Forest
Service

Allegheny National Forest
Bradford Ranger District

File Code: 2830

The Forest Service, surface landowner of the Allegheny National Forest (ANF) in northwest Pennsylvania, files this official objection to the well permit applications submitted by Duhring Resource Company in a revised proposal package on May 26, 2007. The objection is for four (4) wells located in Sheffield Township, Warren County, Pennsylvania on Warrant 2445. This objection pertains to Title 58, Section 601.205 of the Pennsylvania Oil and Gas Act, "Well Location Restrictions."

Proposed Crossing of Rock Run for access to wells D-25 to D-27

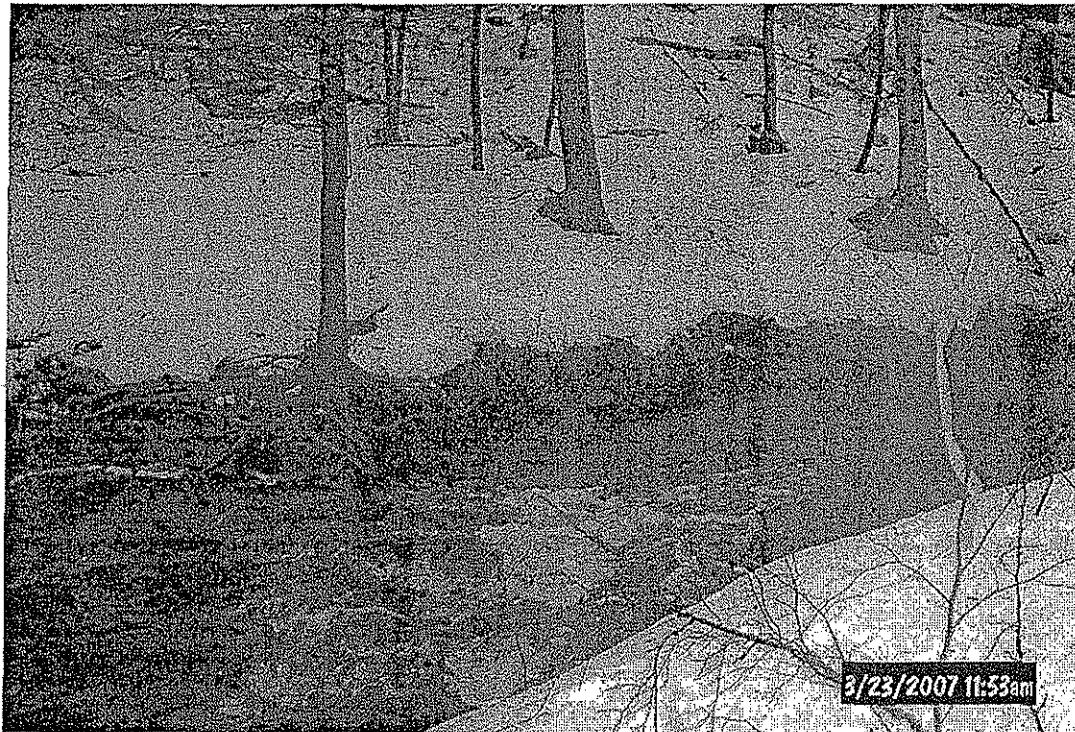
- Well D-26 – This well is located on a steep slope approximately 210 feet from Rock Run. There is not adequate distance between the well site and Rock Run to avoid impact to the stream during construction. This site is not accessible as planned. While acceptable road grades can be achieved, side hill slopes are too steep for standard oil and gas road building practices.

- Well D-27 – This well is located on a steep slope approximately 145 feet from Rock Run. There is not adequate distance between the well site and Rock Run to allow for site construction that would not impact the stream. This site is not accessible as planned. While acceptable road grades can be achieved, side hill slopes are too steep for standard oil and gas road building practices.
